**MEYLE control arm bushing
to fit**

Seat Cordoba, Ibiza, Skoda Fabia, Roomster, VW Fox, Polo

MEYLE-No.: 100 710 0005/HD

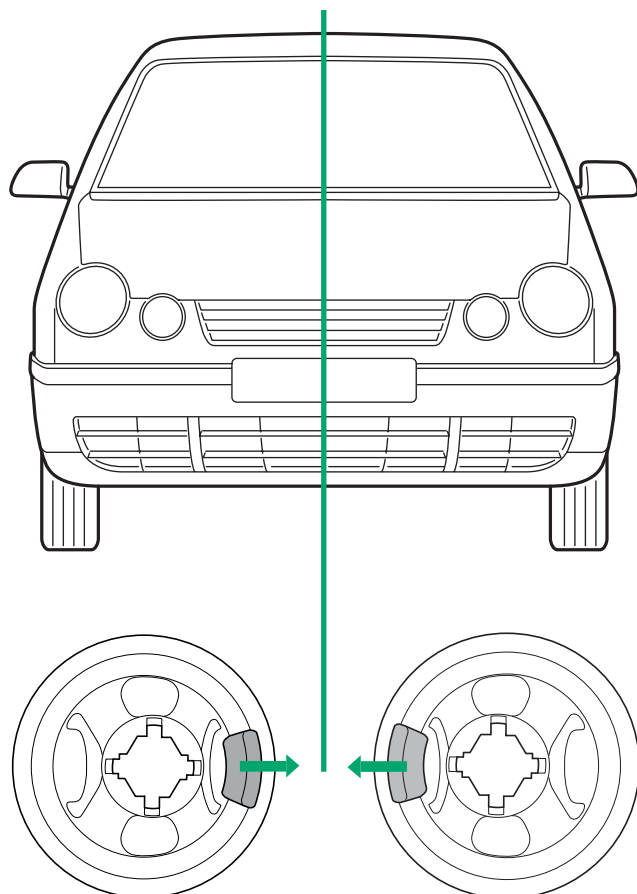
According to VAG the rubber bushing 6Q0 407 183 A (MEYLE-No. 100 407 0077/HD) has been replaced by 1K0 407 183 E (MEYLE-No. 100 710 0005/HD). In the process the bushing design has been modified.

Old: MEYLE-No. 100 407 0077/HD
(Ref. No. 6Q0 407 183 A)

New: MEYLE-No. 100 710 0005/HD
(Ref. No. 1K0 407 183 E)

For correct alignment of the bushing, the ear must be directed toward the middle of the vehicle.
